Mallard Pass Solar Farm Project

This letter introduces Mallard Pass Solar Farm Limited's ('the Applicant's') submissions for Deadline 10 of the Examination.

## Appendix 1 – Applicant's Final comments on Land Use and Soils

KCC ALC

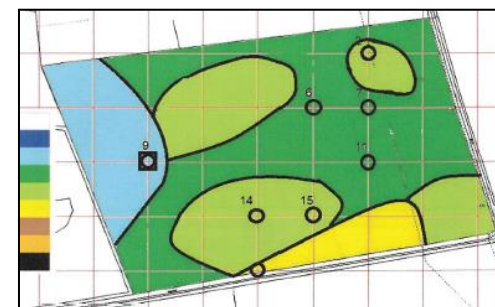
<p>boundary changes have no significant effect on the assessment. The boundary of grades in the area where the substation is proposed, which will involve a small part of that field , was revised but as agreed in the SoCG with Natural England <b>[REP9-019]</b> and in the OSMP, further survey pre-commencement will be carried out to advise the SMP to ensure that suitable soil storage positions will enable full restoration on decommissioning.</p> <p><b>Inclusion of Photos of Soil Pits.</b> These have been provided at Deadline 9. There is no requirement for an ALC report to include these, as the ALC is based on the auger samples, the data for which was provided.</p> <p><b>Boundaries Between Grades.</b> A detailed ALC involves one auger per hectare. A semi-detailed involves usually one auger per 4 hectares. Even with a detailed survey the boundary between grades cannot be accurately determined based on a 100-metre separation between samples, and this is therefore a professional judgement. Two surveys are likely to draw slightly different boundaries. Rob Askew and his team drew the boundaries in this case, and were plotted on the plans.</p>

Landscape states that his survey only redrew boundaries in the areas he surveyed. Their plan for the 8 sample points (below right), and the Applicant's ALC plan (below left) which involved 22 auger samples in the 30 ha are shown below can be compared, enabling a judgement to be made as to whether the redrawing was indeed only in the areas of the eight samples.

**Extrapolation of Results.** The ALC results set out in the ES are based on the semi-detailed and detailed ALC. There is no extrapolation. Whilst some of the survey is semi-detailed, there is general agreement from all except MPAG that this provides adequate information for the assessment. That should be particularly so because the land quality will not be lost by sealing or downgrading.
